### 243 HANOVER STREET REVISIONS AND MATERIAL SPECS

#### SUMMARY OF CHANGES AND SCOPE OF WORK

#### HPC Public Hearing Application for Certificate of Approval

(See Attached Rough Drawing)

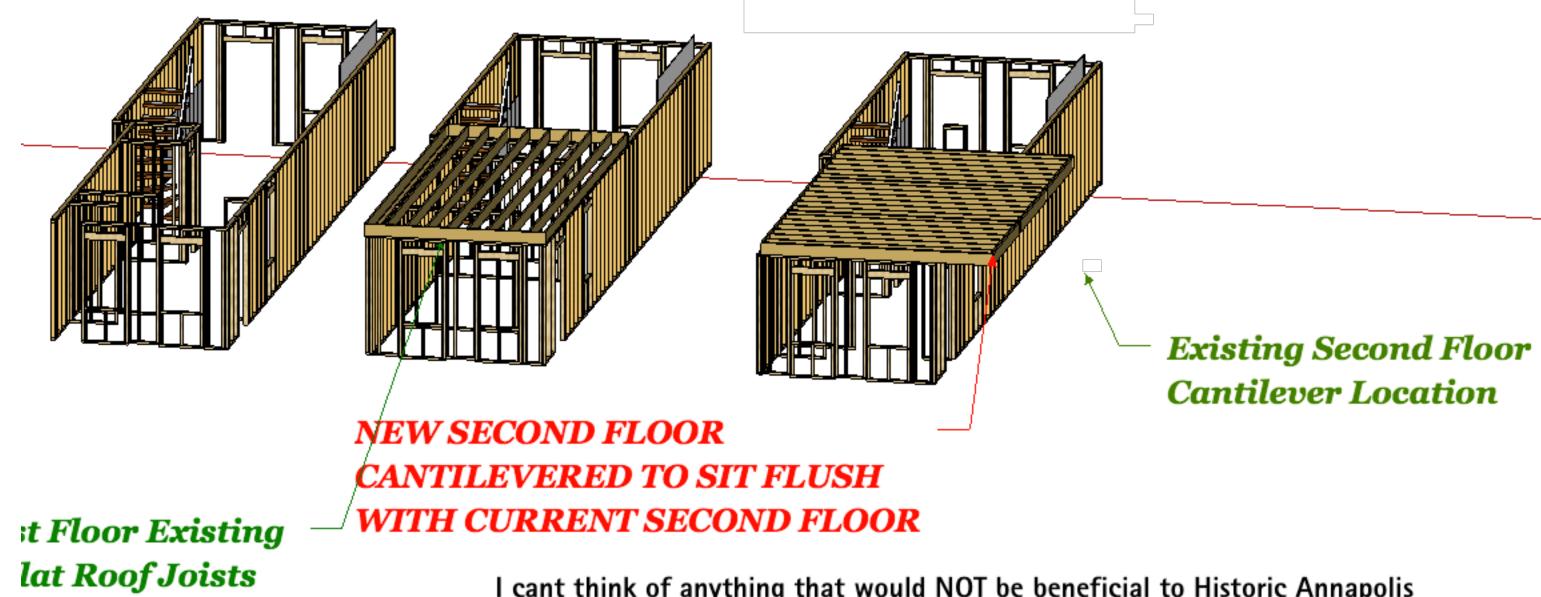
Also, for your humor, I will attach a picture of me doing my first CAD drawing trying to show you guys

the new materials being installed on the house. It's comical but also somewhat informative to what we are looking to do! The colors will match the current house colors. Windows white and wood siding is a yellowish color that will be matched. Thanks so much for your time and have a great day!
